Low/Intermediate Upgraded Servo, Spring, Pin & Retainer Clip

Sonnax Part Summary

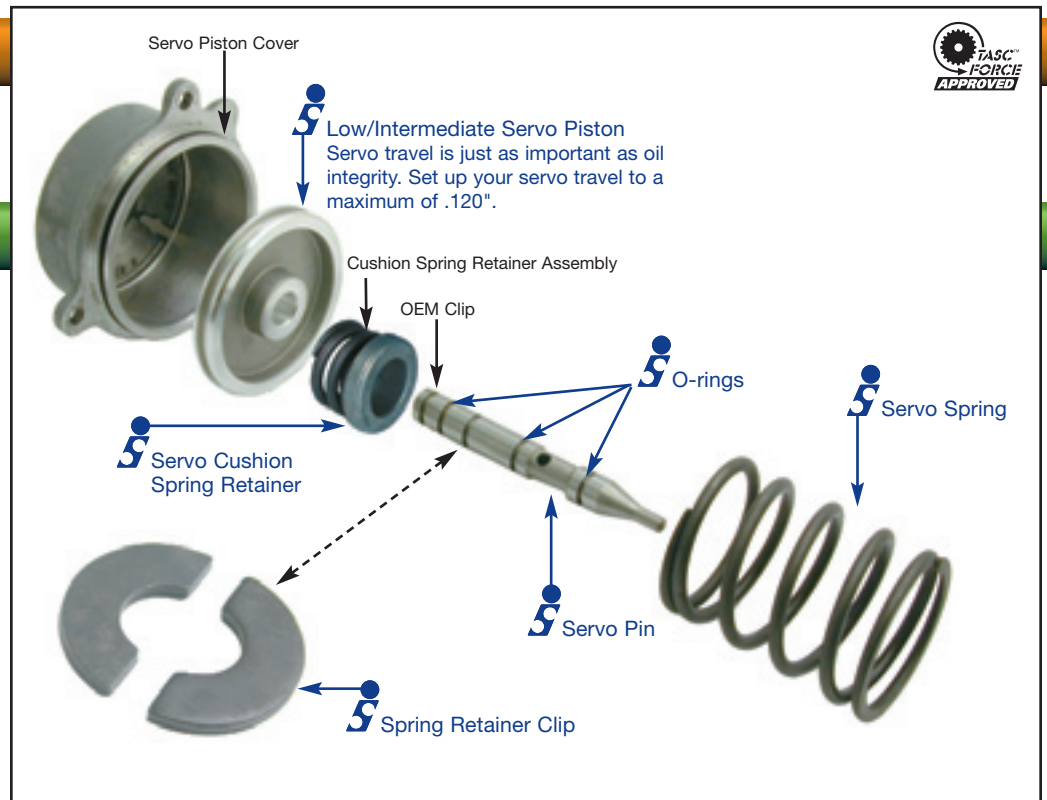
Servo pin-bore leakage, incorrect spring calibration, case bore leakage at pin, and broken parts.

The replacement servo corrects leakage at the pin bore, the modified spring rate provides better servo timing, and the servo pin has o-rings for positive sealing.

- Replacement servo piston eliminates leakage at the pin bore.
- Updated spring is longer and has a spring rate approximately 12 lbs. lighter than the OEM, reducing delayed forward engagements.
- Spring eliminates downshift clunk complaints because it is stiffer than the common Chrysler replacement spring.
- Updated servo spring retainer clip is made of hardened steel for better wear resistance and has full contact on the pin groove radius, preventing breakage of the OEM clip.
- Replacement servo pin incorporates 3 o-rings for positive sealing and leakage prevention.
- Replacement servo cushion spring retainer not available from OEM.
